Title: Advisory Committee on Reactor Safeguards
 ABWR Subcommittee: Open Session

Date: Tuesday, October 4, 2011

Action Item # 98 - Perforated Metal Sheet Analysis Method

Action Item # 98 - Validation of Method Applicability *(continued)*

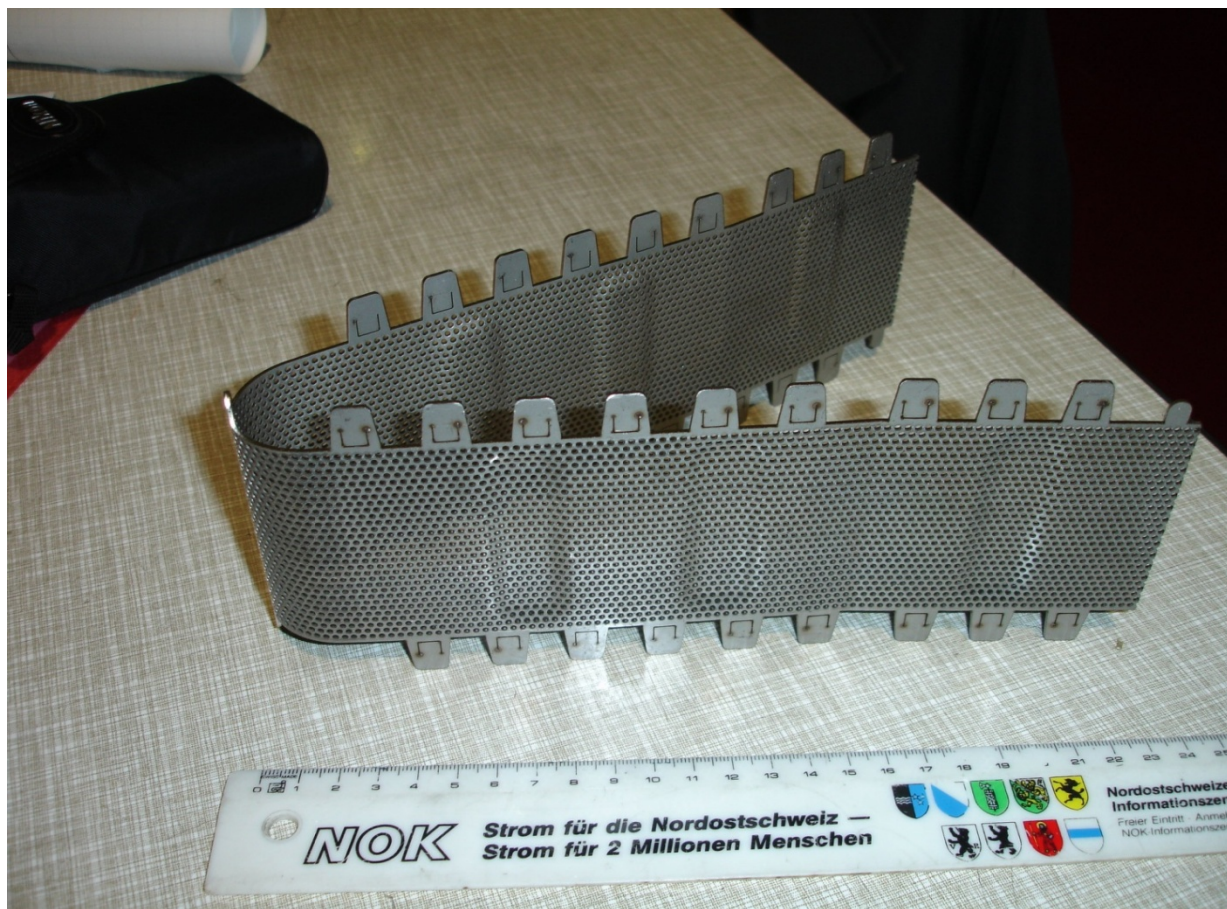
3 CONSULTANT WALLIS: I understand. What is
4 yielding? Is it yielding and bending or what? Which
5 way is it yielding? You have to show me the test,
6 because 1 millimeter doesn't mean anything unless I
7 know 1 millimeter of what.

2 CHAIR ABDEL-KHALIK: Well, if you show us
3 whether -- the sample how it was tested and whether it
4 is bending, you know, we will be able to figure that
5 out. I just --

16 MEMBER SHACK: When I saw the pictures of
17 this, I always assumed those pockets were perforated
18 on all sides. You are telling me that it is really
19 two solid plates and a porous U? Which comes back to
20 Said's question of whether this is really totally
21 representative of the geometry.

19 CONSULTANT WALLIS: But it's also a
20 question of how you -- what you did with these tabs.
21 I mean, this thing is fixed to the other plate with
22 these tabs.

13 MEMBER ARMIJO: Well, it looks like the
14 test confirmed what they wanted to confirm, but it
15 didn't tell us whether a prototypical pocket,
16 completely prototypical, would behave the same way,
17 because they didn't test it. And that's really the
18 question that is in front of us, you know.

20 MEMBER SHACK: Well, let me try another
21 argument here that what you have really demonstrated
22 with this test is that you can undergo a considerable
23 amount of plastic deformation in this sheet and not
24 tear locally.

(202) 234-4433

2 MS. SCHLASEMAN: But for the test, they
3 didn't use the side plates. That's correct, they are
4 perforated on the sides. But in this test fixture,
5 they did not do it that way.

12 MS. SCHLASEMAN: But I think considering
13 how the -- if the plates were -- on the side had been
14 the perforated sheets, and, obviously, they would be
15 weaker, I mean, surely they would be weaker, but
16 because of the way you are loading it, you are loading
17 it like a membrane. And so I'm still thinking that
18 the load -- you know, the question about the holes
19 tearing open and the pockets -- I mean, that was your
20 original question about whether or not the pockets
21 would tear open, and I'm not seeing how it would
22 necessarily tear open differently.

Figure 19E.2-6a: UO₂ Temperature

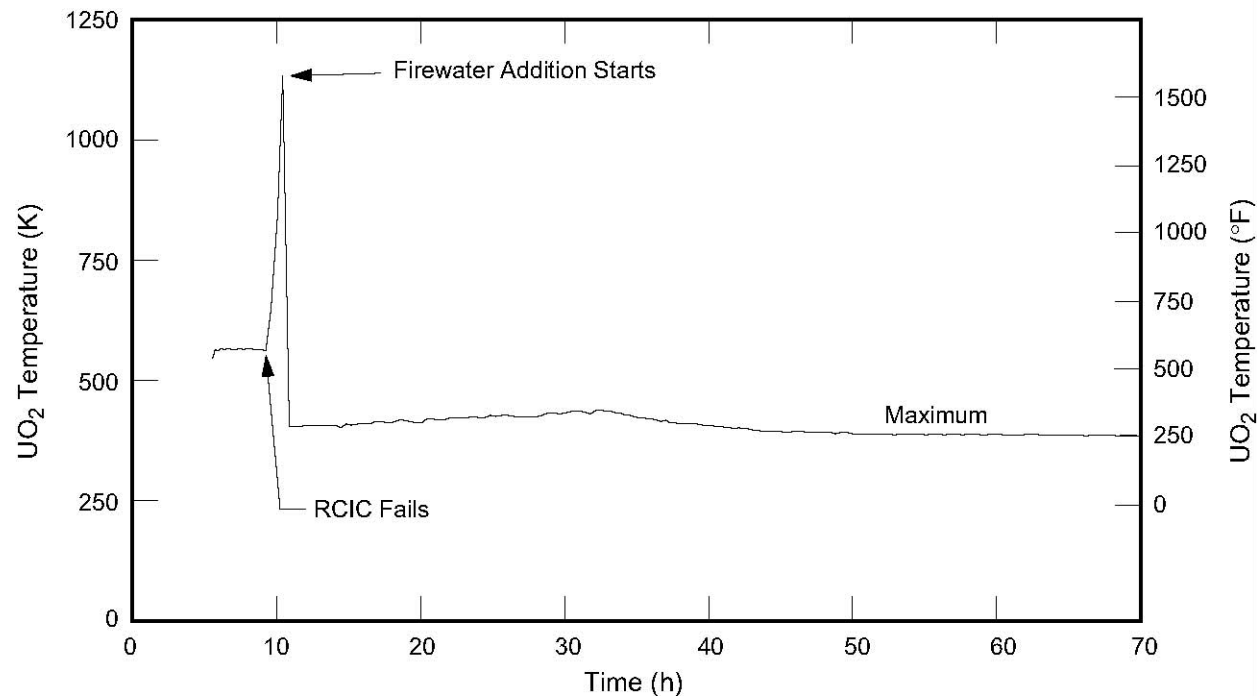
9 CONSULTANT WALLIS: So it looks as if it
10 makes a difference of -- you know, if you move this
11 thing by 10 minutes one way or the other, you can
12 change that spike quite a bit.

12 MR. THOMAS: On the next sheet, this just
13 shows the plot of the fuel temperature throughout this
14 transient. As you can see, when RCIC injection
15 ceases, you get a pretty significant spike in fuel
16 temperature. The peak is 1610 degrees from the
17 analysis, which is below the -- it's the level at
18 which we anticipate fuel damage.

Figure 19E.2-6a: Drywell Pressure

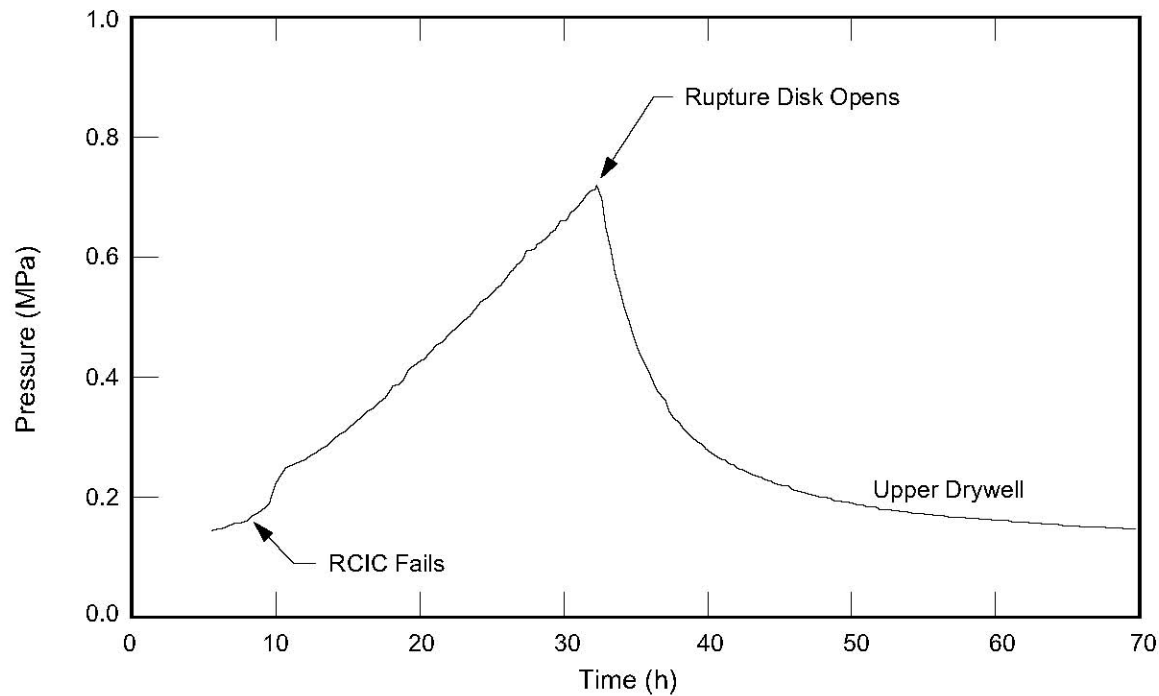
8 CONSULTANT WALLIS: So this just -- excuse
9 me. This Slide 7 is responding to my question, isn't
10 it? This is over-raced, but we getting the firewater
11 going and the water level falling in the vessel?

2 Likewise on the next sheet, if you look at
3 containment pressure, when RCIC fails, of course,
4 containment pressure starts to increase pretty
5 dramatically until the rupture disc opens again at 90
6 pounds. It decreases rapidly and again approaches
7 equilibrium for a considerable period of time.
